ADDENDUM NO. 2
TO
PROCUREMENT AND CONTRACTING REQUIREMENTS
FOR
Sweetser Wastewater Improvements
FOR
Town of Sweetser
Issue Date: September 17th, 2026

ATTACHMENT NO. 1
REVISED SHEET E113

ATTACHMENT NO. 2
REVISED SHEET A301

EAGLE DRIVE LS
ELECTRICAL DETAILS -
PROPOSED

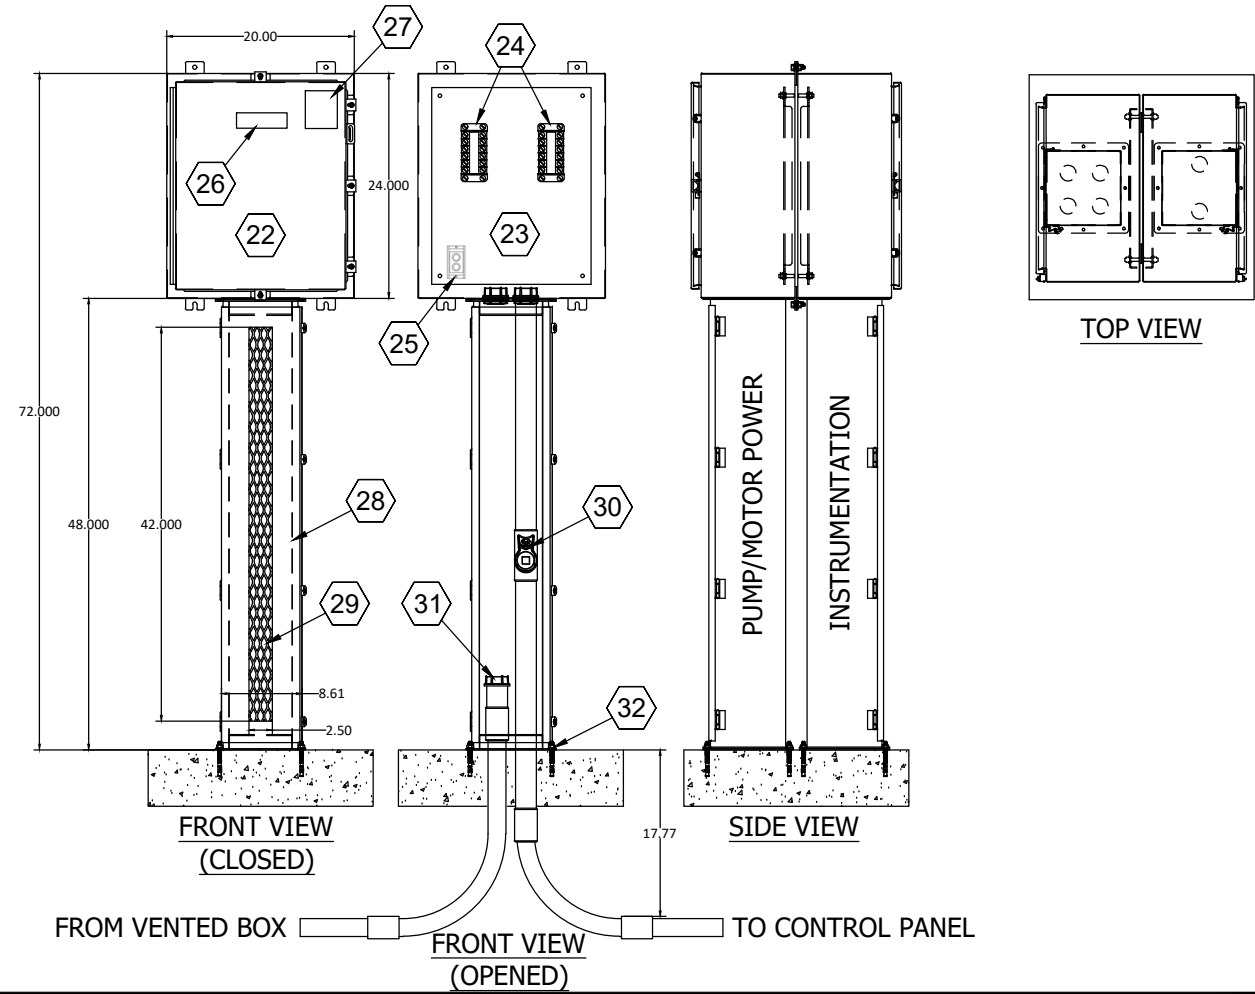
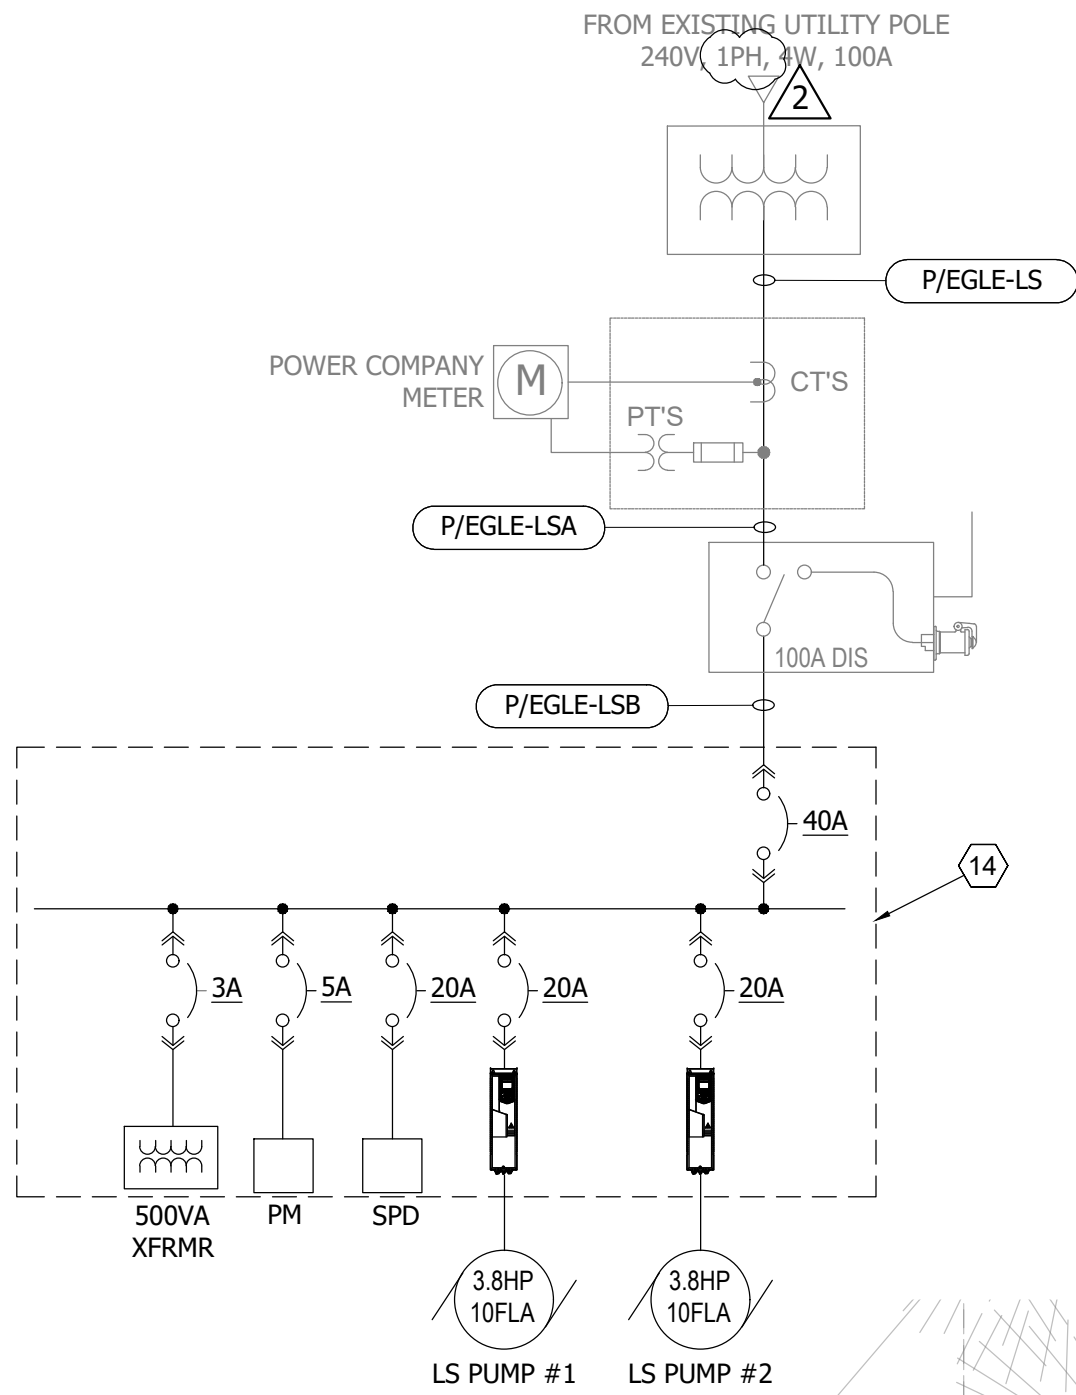
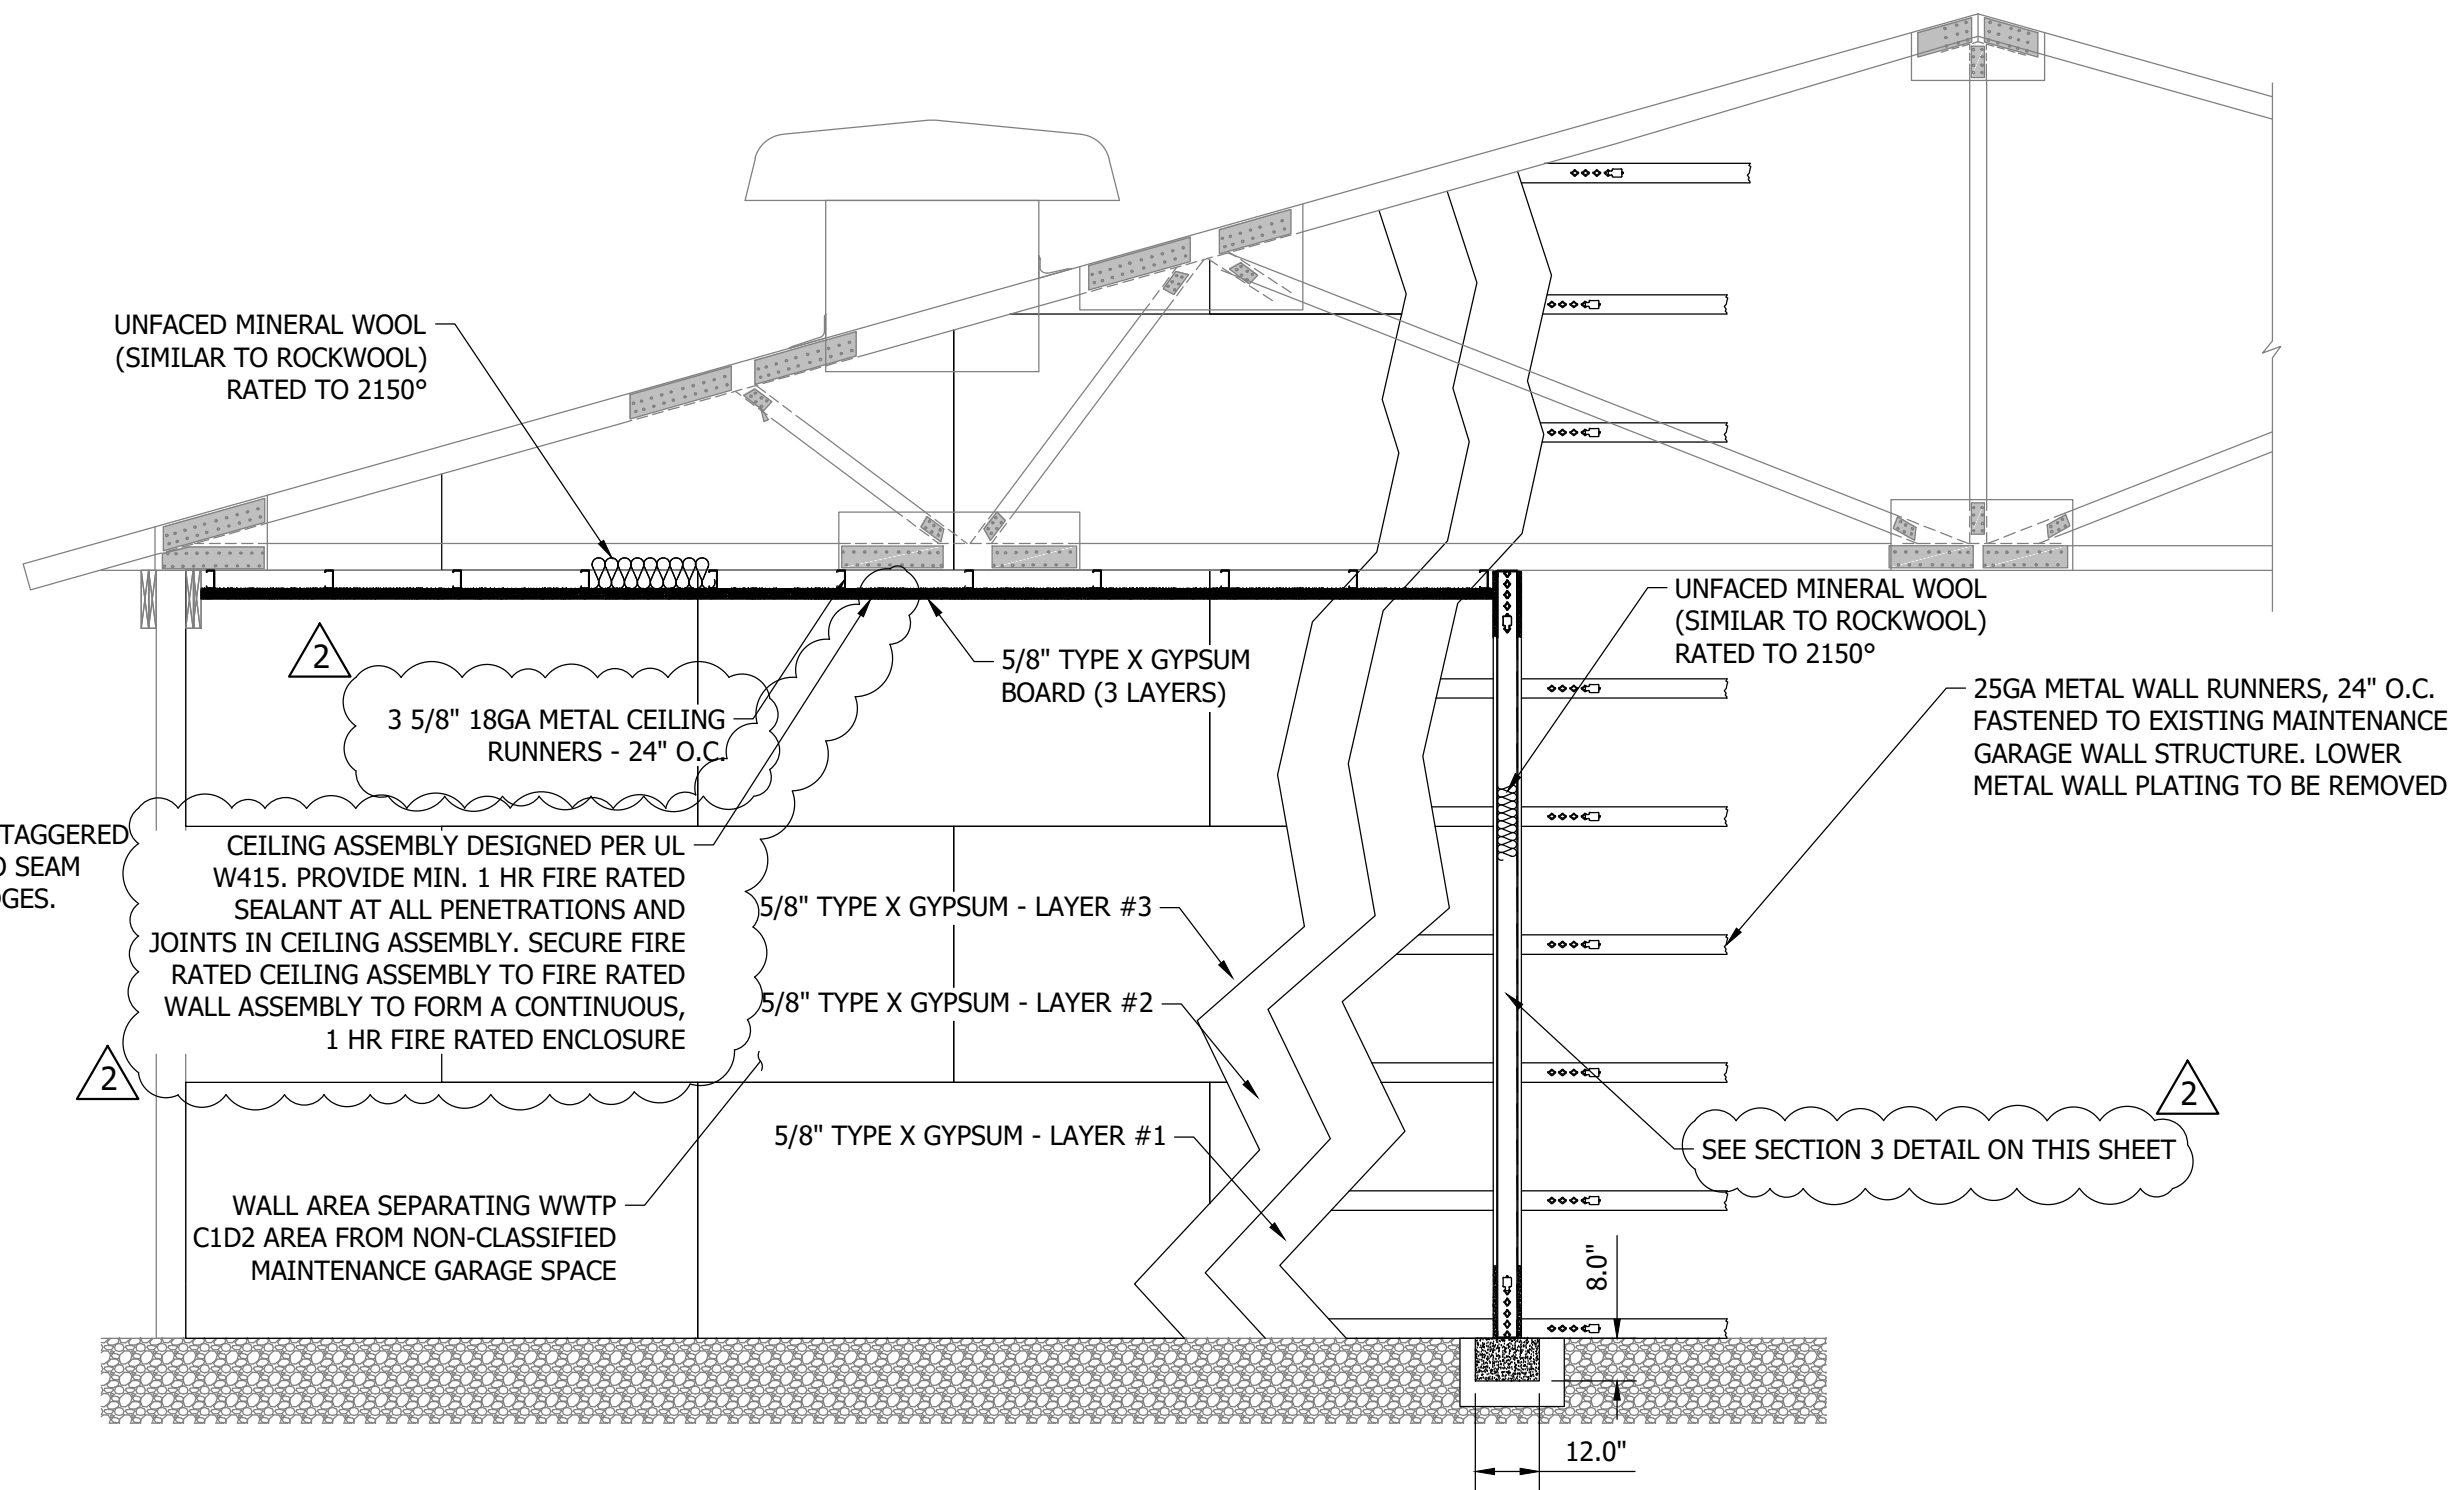
1. Updated E113 sheet index (**Attachment No.1**).
 - a. Updated to show proper voltage and phase feeding the Eagle Drive Lift Station.
2. Updated A301 (**Attachment No.2**).
 - a. Updated notes relating to ceiling and wall assemblies. Updated the ceiling runners to be 18 GA rather than 25 GA.

2. Q: (Vendor Question) Sheet E113 indicates 240/3 input power and Sheet 109B indicates 240/1 for the Eagle Drive Lift Station Panel. Please verify site voltage/phase that will be feeding the VFD control panel at that lift station.

- A. *The power feeding the Eagle Drive Lift Station is 240V, single phase. Please see **Attachment No. 1** for the revised voltage/phase feeding the VFD at Eagle Drive Lift Station.*

- EXISTING UTILITY UNDERGROUND 100A SERVICE. 240V, 1PH. LIFT STATION UNDERGROUND SERVICE TO BE RELOCATED FROM EXISTING TRANSFORMER TO NEW EQUIPMENT RACK.

- EXISTING UTILITY TRANSFORMER. TO REMAIN.
- EXISTING 240V, 1PH, 100A RONK 7103 MAIN DISCONNECT AND MANUAL TRANSFER SWITCH. TO BE RELOCATED TO NEW RACK.

PROPOSED UV AND
BLOWERS ROOM
SECTIONS AND DETAILS

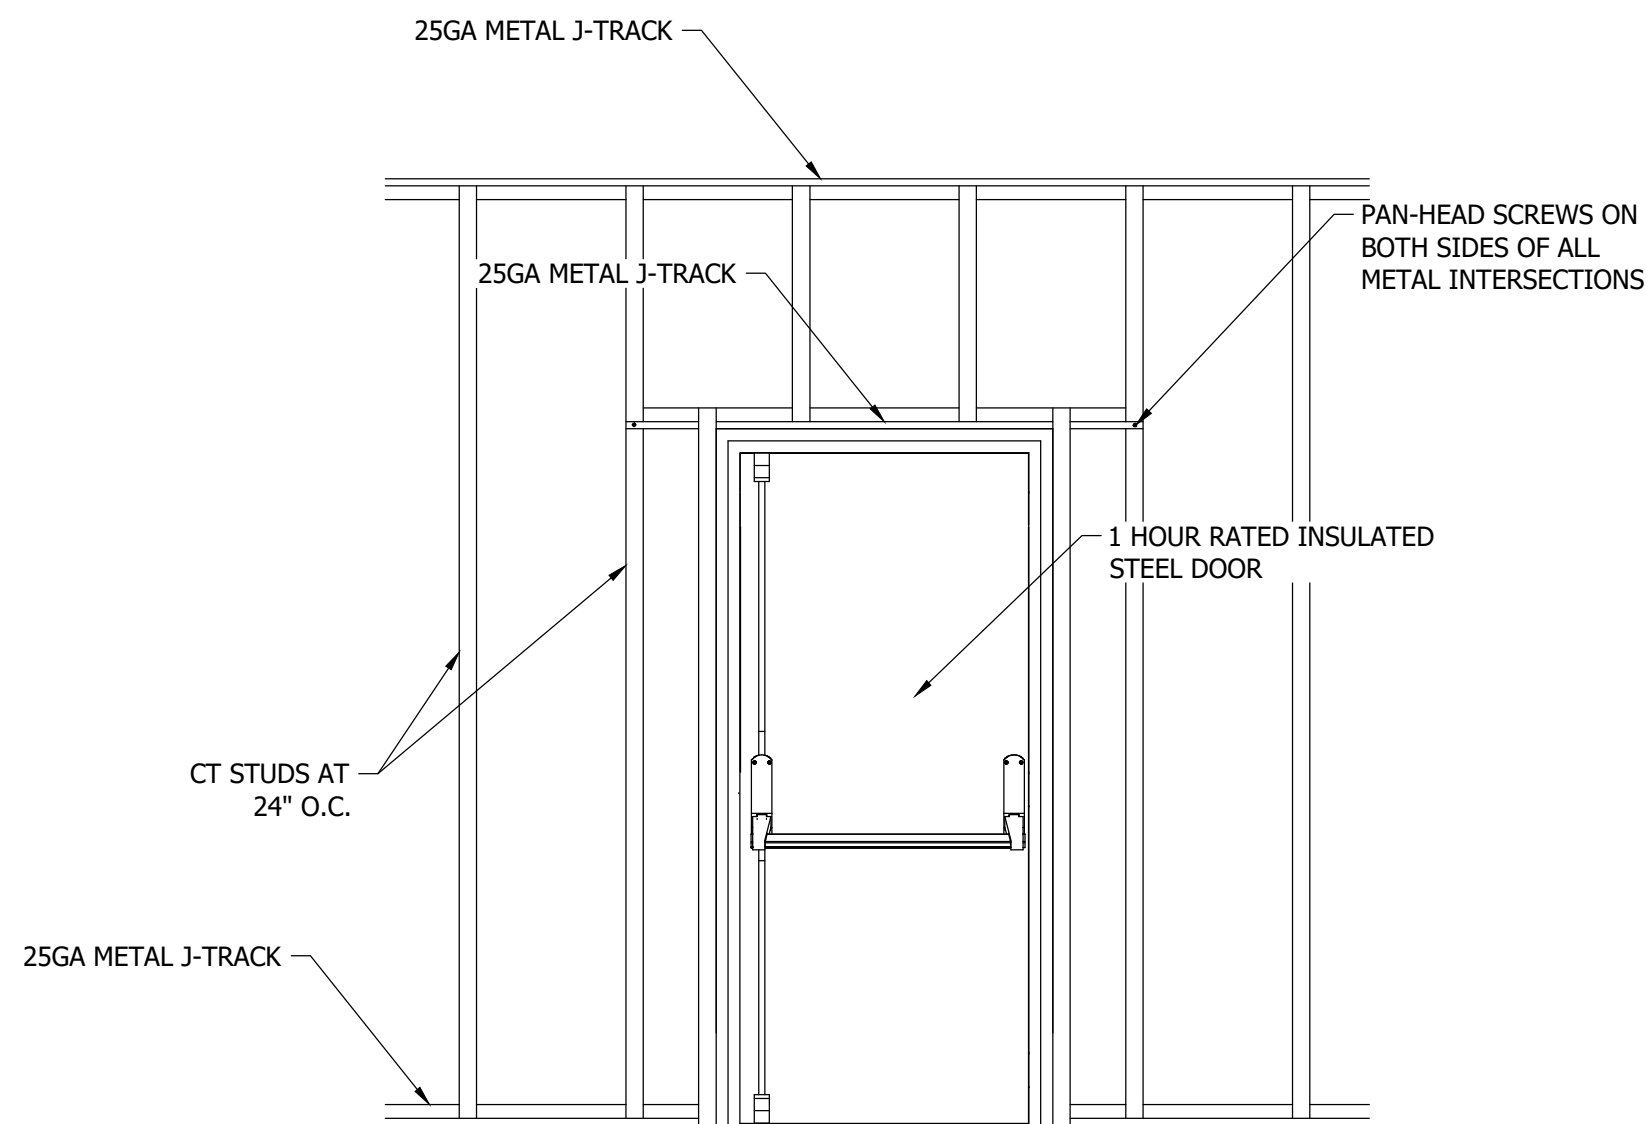
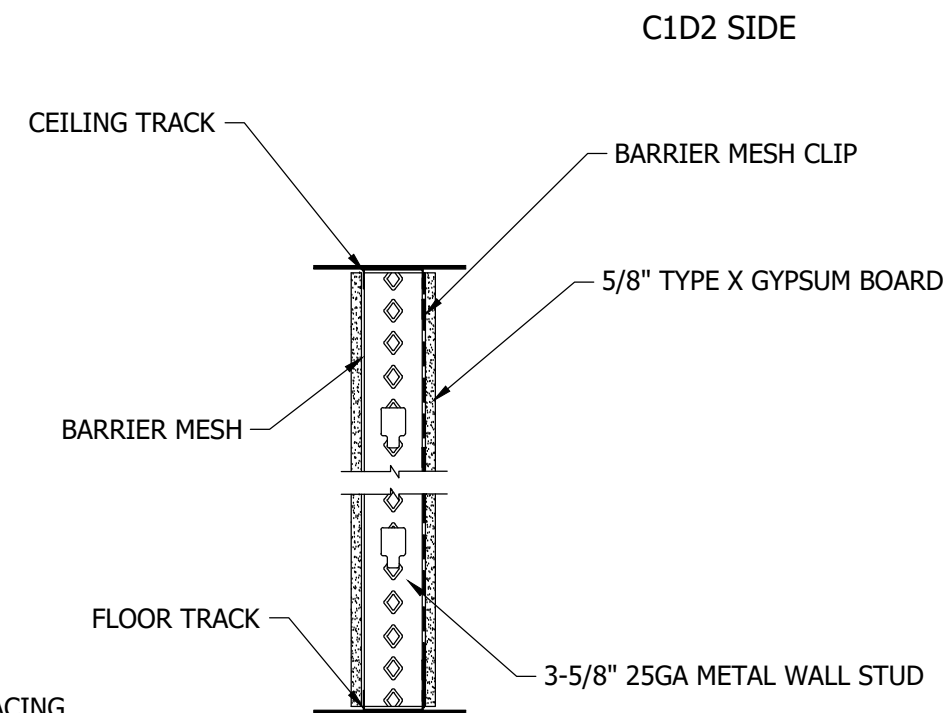
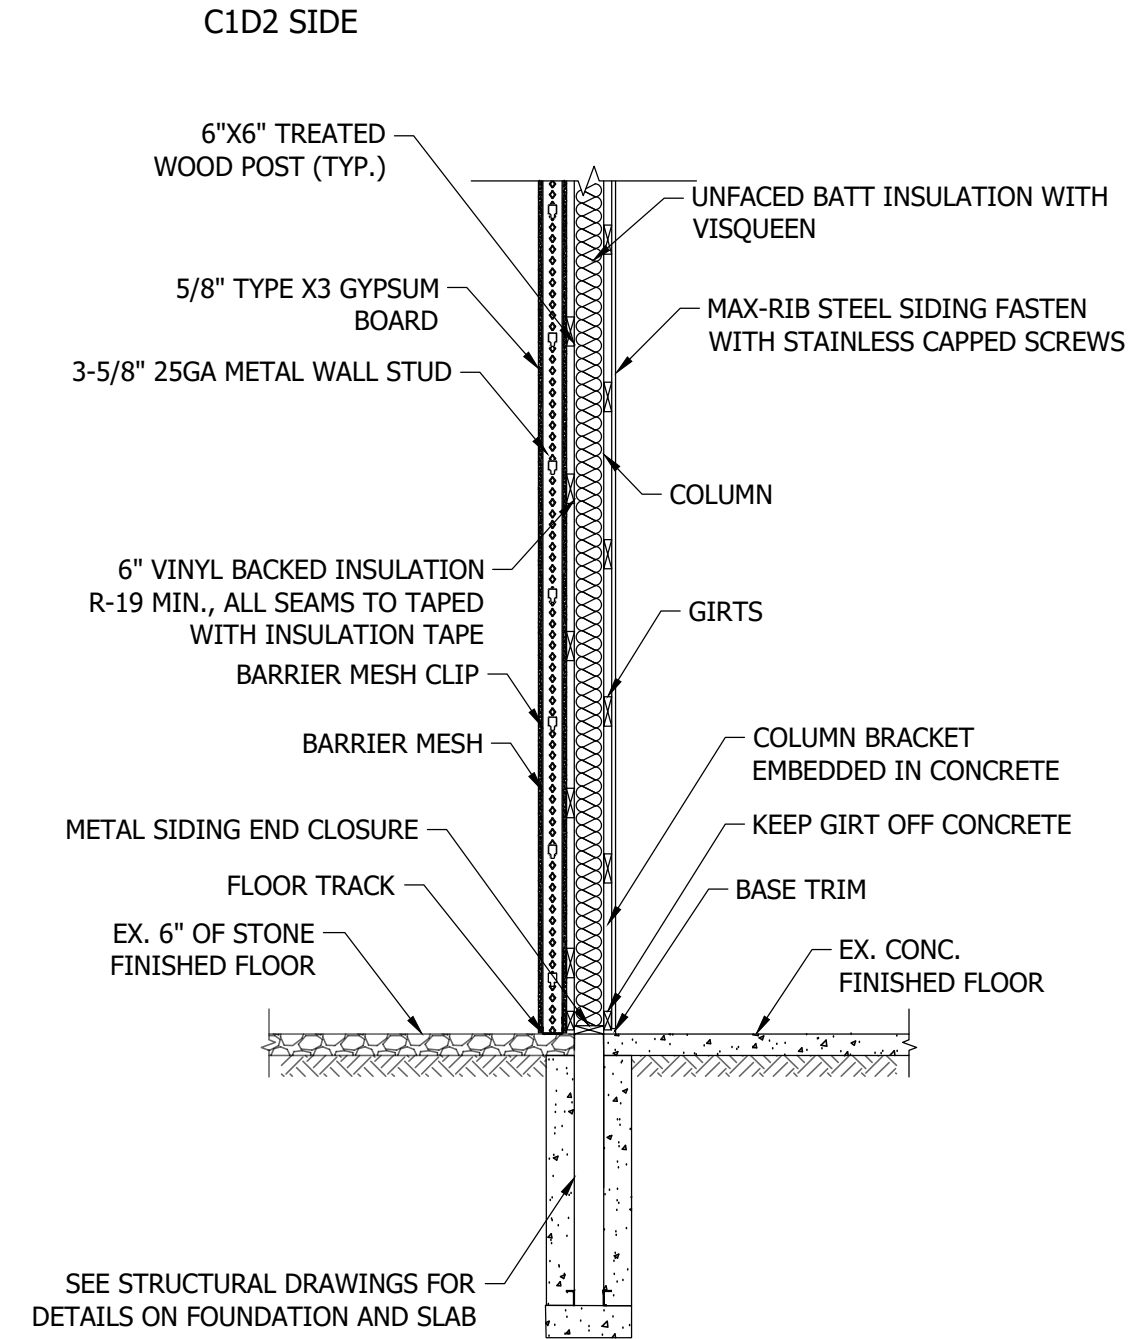
5. Q: (Contractor Question) Please clarify the language regarding the ceiling in the key notes on Sheet C105. Is the intent for the FRP to be directly mounted to the hat channel or a suspended ceiling grid system?

6. Q: (Contractor Question) Please provide a thickness and spec for the FRP panels.
 - A. *Please see the response to Question 5.*

- A. *The intent is for FRP panels to be directly mounted to the underside of the hat channel. The basis of design for the direct-attach FRP panel system is Trussco or approved equal.*

3. WALL ASSEMBLY DESIGNED PER UL U419, 1 HR RATED CONFIGURATION. PROVIDE MIN. 1 HR FIRE RATED SEALANT AT ALL PENETRATIONS AND JOINTS IN WALL ASSEMBLY. SECURE FIRE RATED WALL ASSEMBLY TO FIRE RATED CEILING ASSEMBLY TO FORM A CONTINUOUS, 1 HR FIRE RATED ENCLOSURE.
